SERVICE BULLETIN RELEASE - 10/03/2014

05-010/14 - 2010-2015 CX-9 - DIFFICULT TO MOVE SELECTOR LEVER OUT OF "P" RANGE

Subject: DIFFICULT TO MOVE SELECTOR LEVER OUT OF "P" RANGE	Bulletin No: 05-010/14
	Last Issued: 10/03/2014

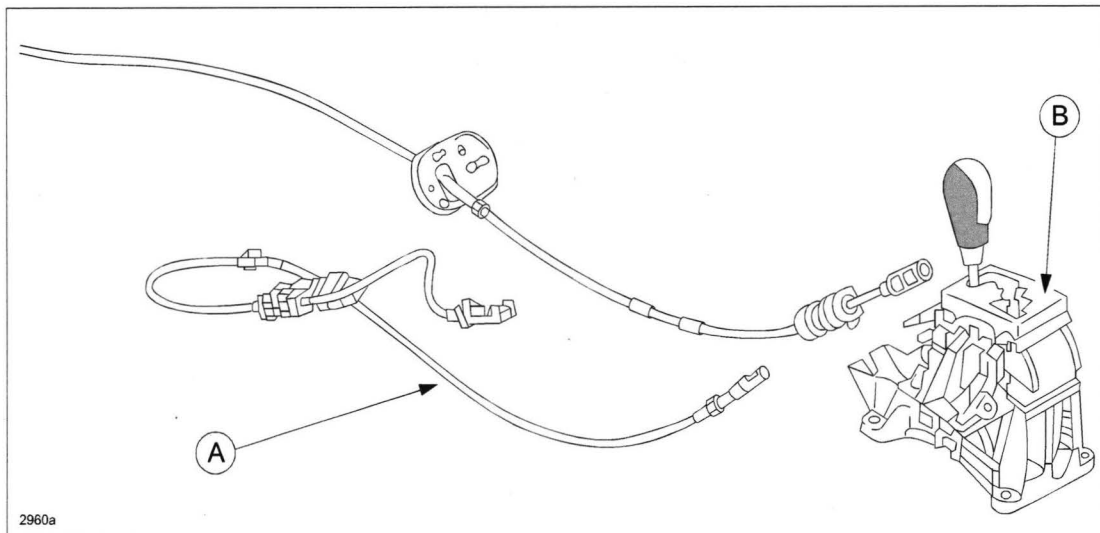
Some customers may experience difficulty moving the selector lever out of "P" range after the vehicle has been parked overnight in extremely cold temperatures (i.e. below freezing). The selector lever movement may return to normal after running the climate control system at maximum hot for short period of time.

This concern may be caused accidentally by the customer spilling a drink around the selector lever. When the spilled liquid reaches the interlock cable and freezes overnight, it causes the customer to have difficulty moving the selector lever out of "P" range the next morning.

1. Verify the customer concern.
2. Replace the interlock cable (A) according to the instructions on MS3 online or the Workshop Manual (section 05-18 AUTOMATIC TRANSAXLE SHIFT MECHANISM REMOVAL/INSTALLATION).

NOTE: Advise the customer to take the necessary precautions to avoid spilling liquids around the selector lever (B) area.
